Access Compliance Report

Public Rights-of-Way

Intersection ID: 25500	Main Street: PINEVILLE-MATTHEWS_RD	Cross Street: STRAWBERRY_LN	Location: NE
ADA ID: C22D45DDEACF	Ramp Type: BlendTrans2	Initial Pass/Fail: Pass	Overall Compliance: No
		Severity Score: 0

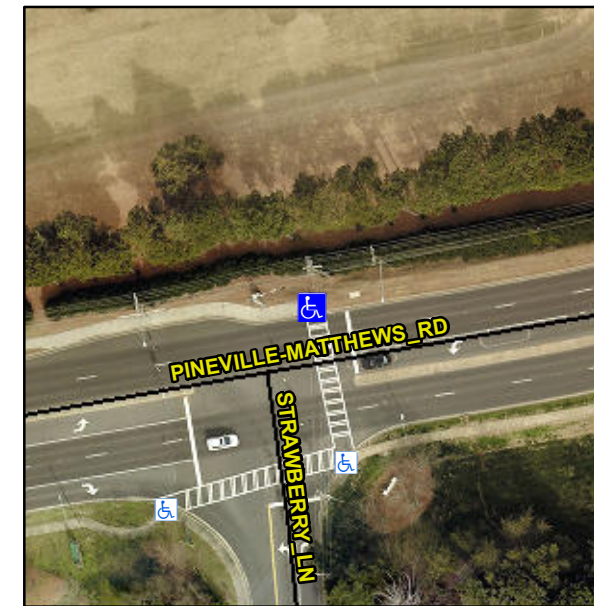
Remove & Replace Flare.

R304.2.3
